Field Service Bulletin Trucks

Date Group No. Release Page 5.2018 **373 025 01** 1(6)

Headlamp Harness, Repair VN, VHD, VAH

FSB 373-025, Headlamp Harness, Repair

W3135505

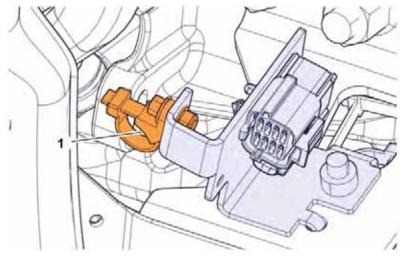
- 1 Remove the cable ties securing the headlamp harness to the J-bracket and connector bracket.
- 2 Inspect the harness for damage. If damage is found, repair or replace the harness as necessary.
- 3 Install the cable harness attachment retainer as shown. Be sure that the harness saddle is in the down position.

Object	Part Number	Description		
1.	8081349	Harness Retainer

W3135506

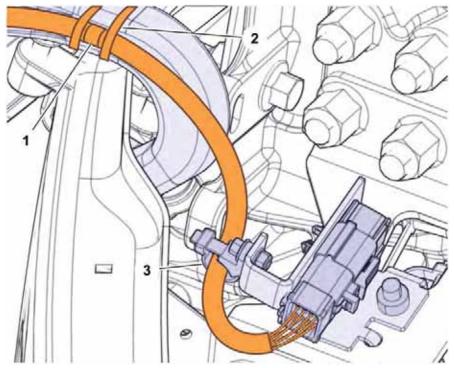
4 Route the harness accordingly.

Object	Part Number	Description		
1.	N/A	Yellow Harness Tape		
2.	98464	Cable Tie		
3.	1578046	Cable Tie

W3135540

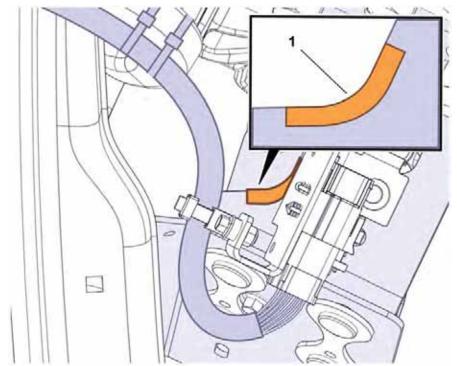
5 Install the edge protector.

Object	Part Number	Description		
1.	3083128	Edge Protector
